MONTGOMERY COLLEGE - OFFICE OF PROCUREMENT
MACKLIN TOWER MBI FINANCE LAB SUITE 100, ROCKVILLE CAMPUS
RFP NO.: 620-011
RFP CLOSING DATE AND TIME: APRIL 7, 2020 @ 3:00 PM

ADDENDUM #1
Issued: March 27, 2020

Project:	MC RV MT MBI FINANCE LAB SUITE 100 RENOVATIONS	Date:	03/25/2020
		Reference:	
Title:	Addendum #1 Drawing Narrative	BKM Project No:	19106.01

SHEET TITLE: ENLARGED PLANS AND ELEVATIONS

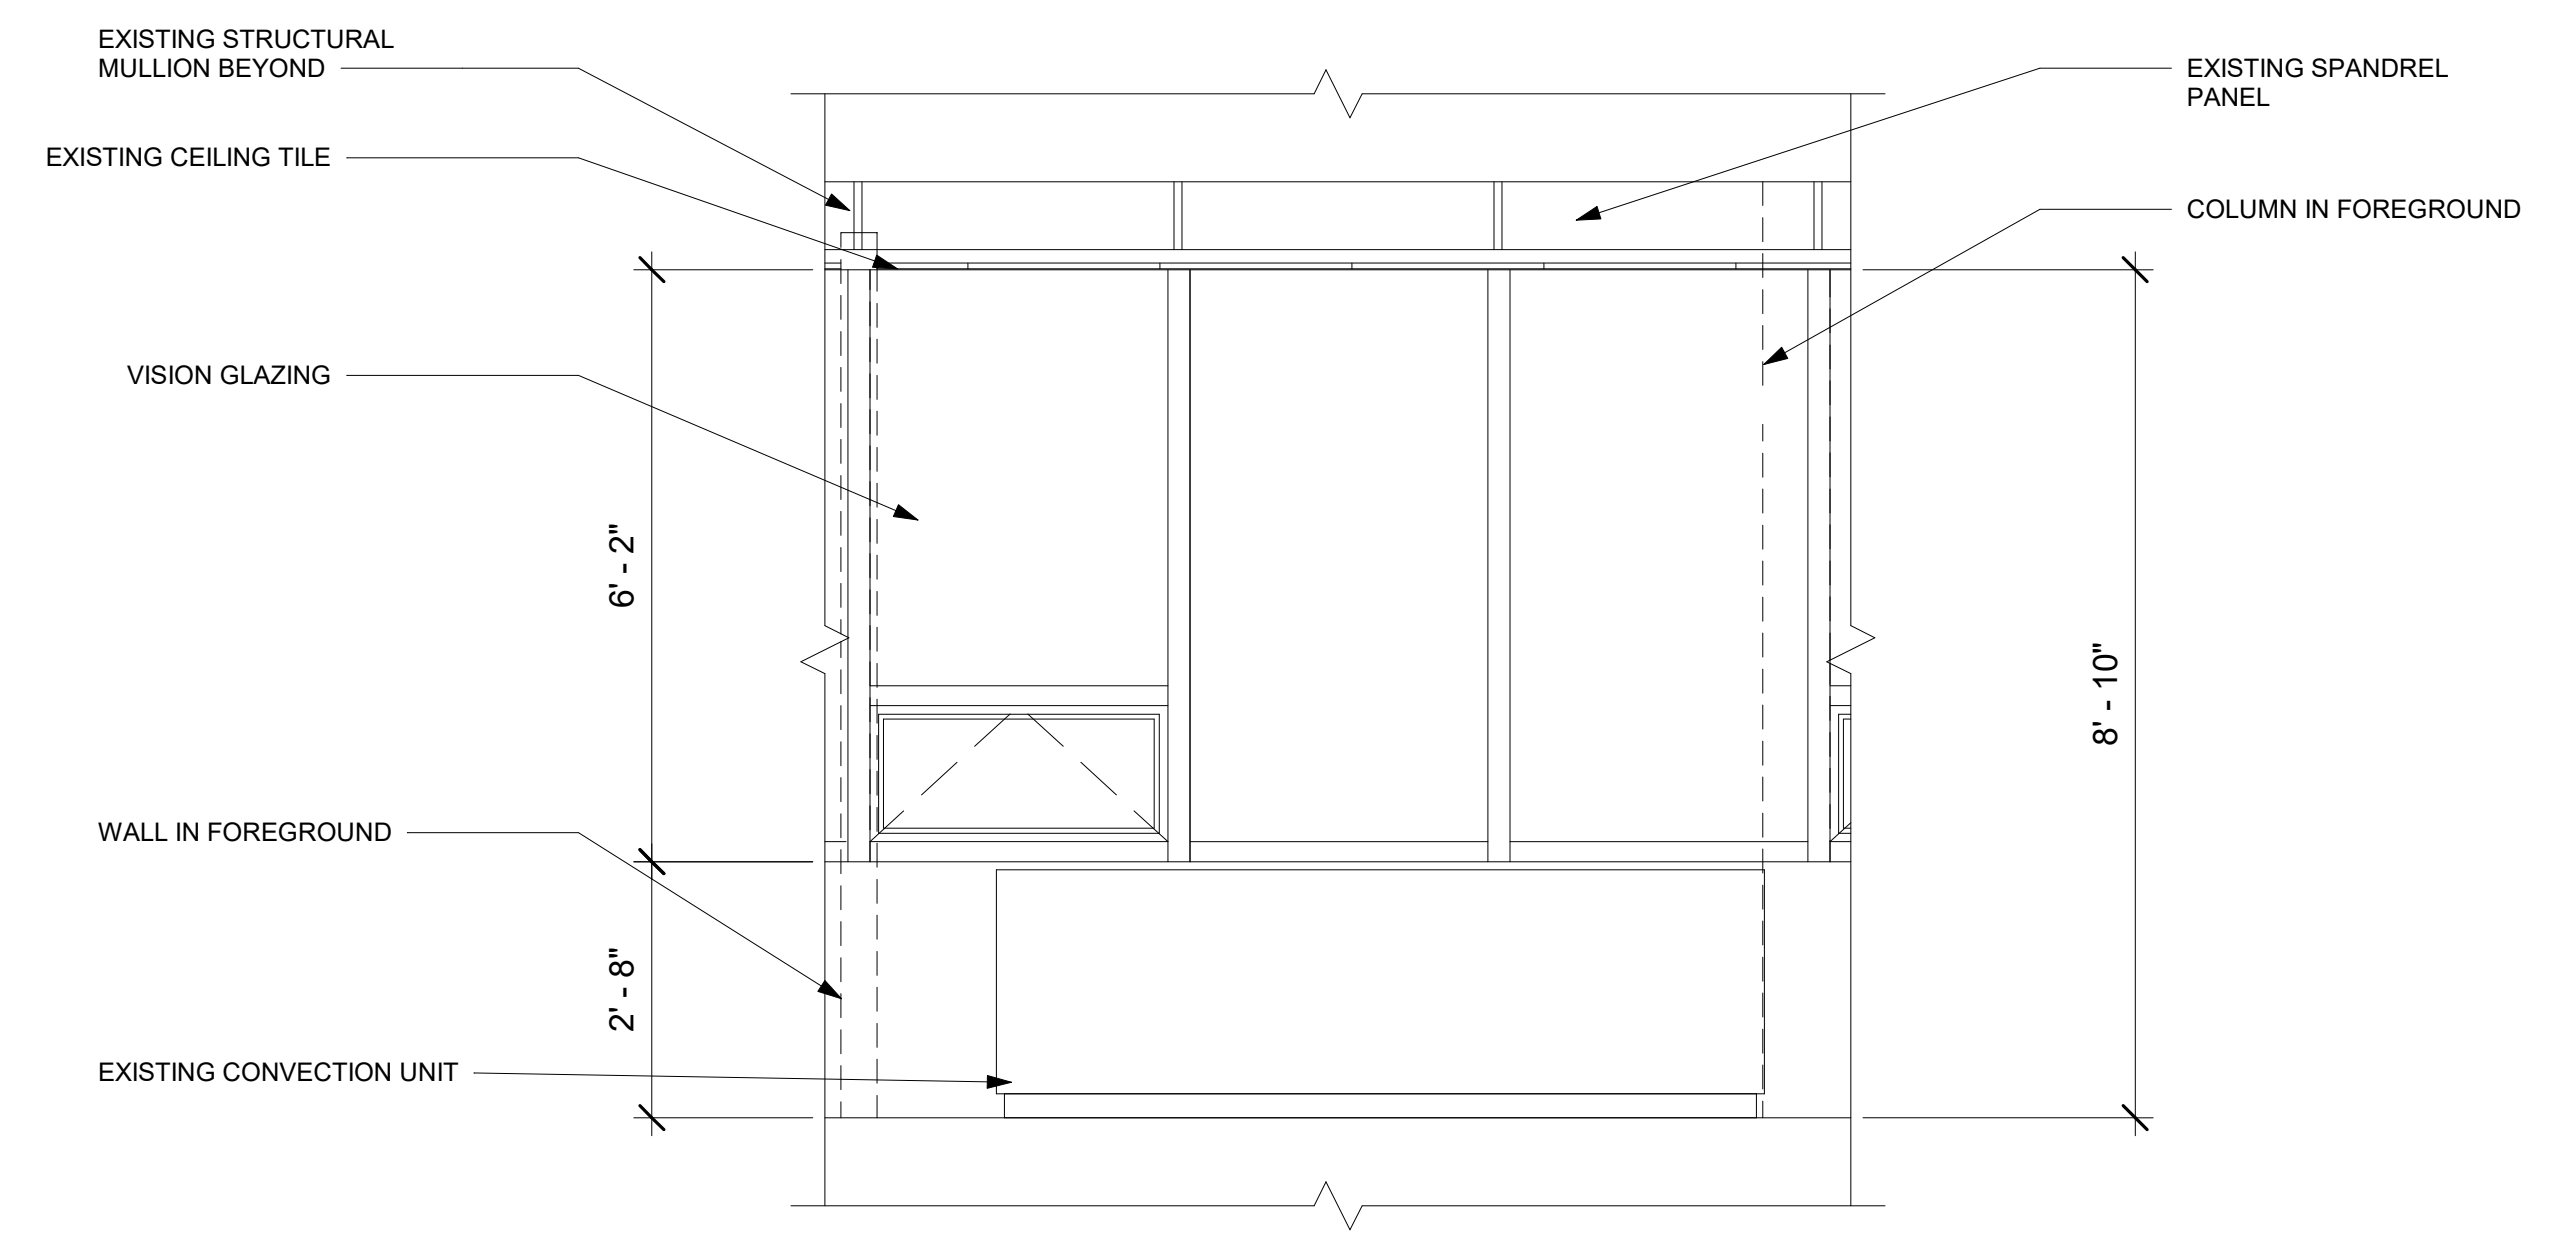
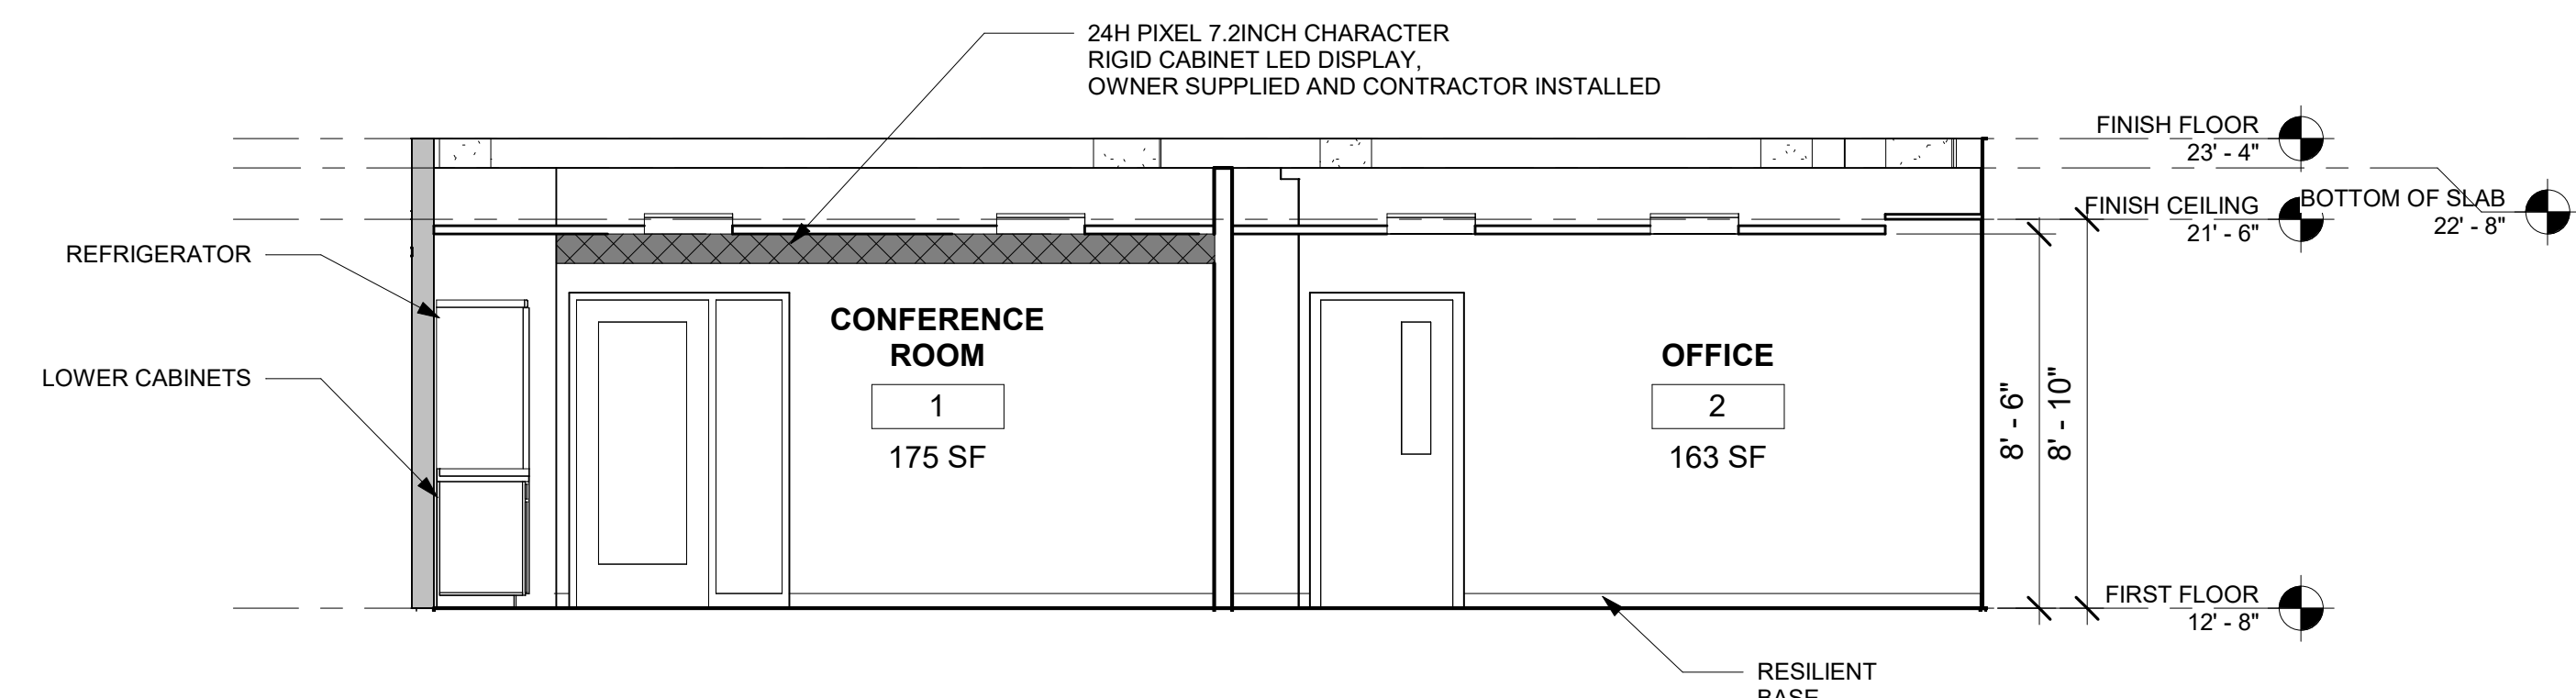
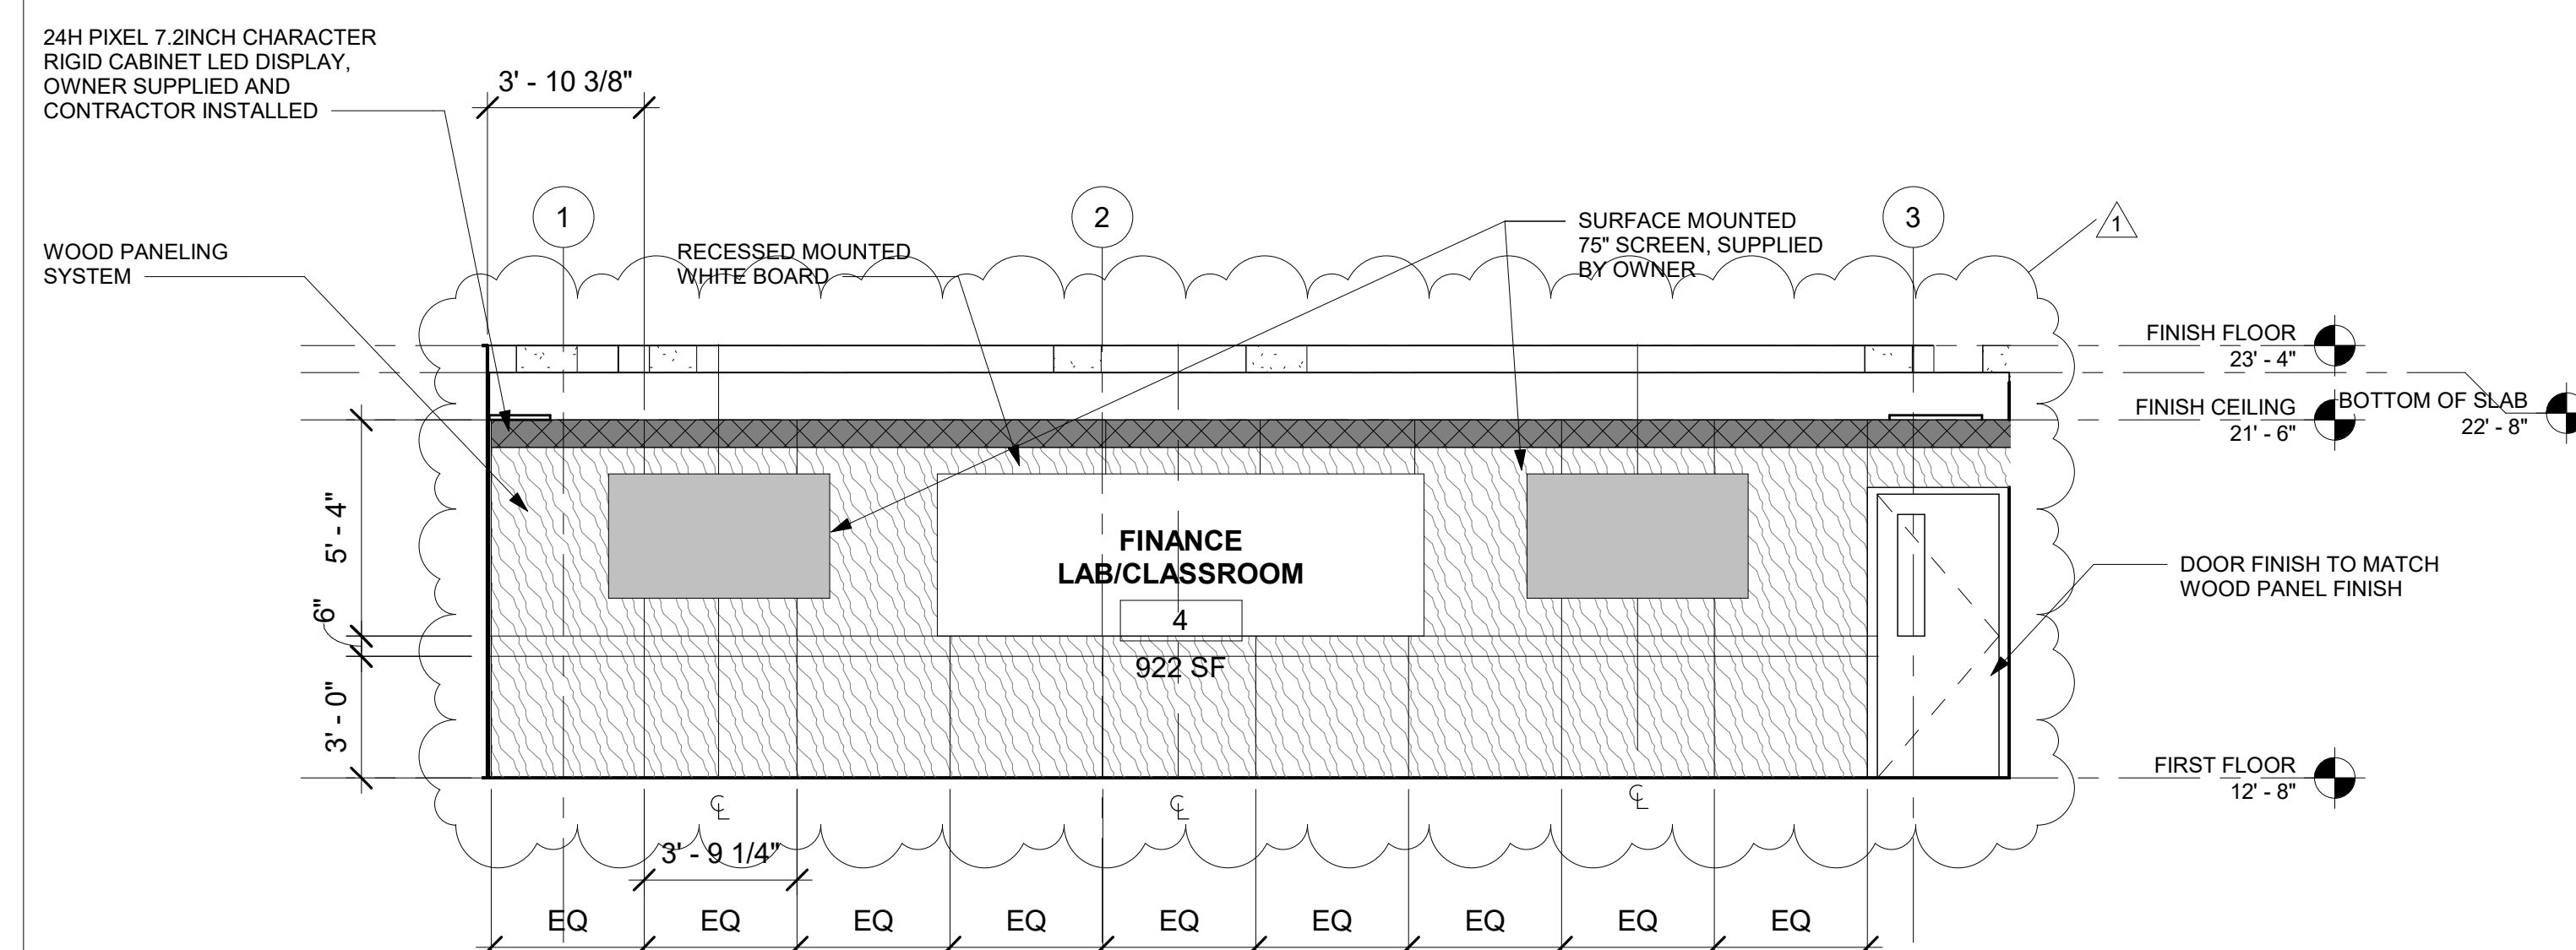
A4.01 – Enlarged Plans and Elevations

- Enlarge Plan and Elevations have been revised.
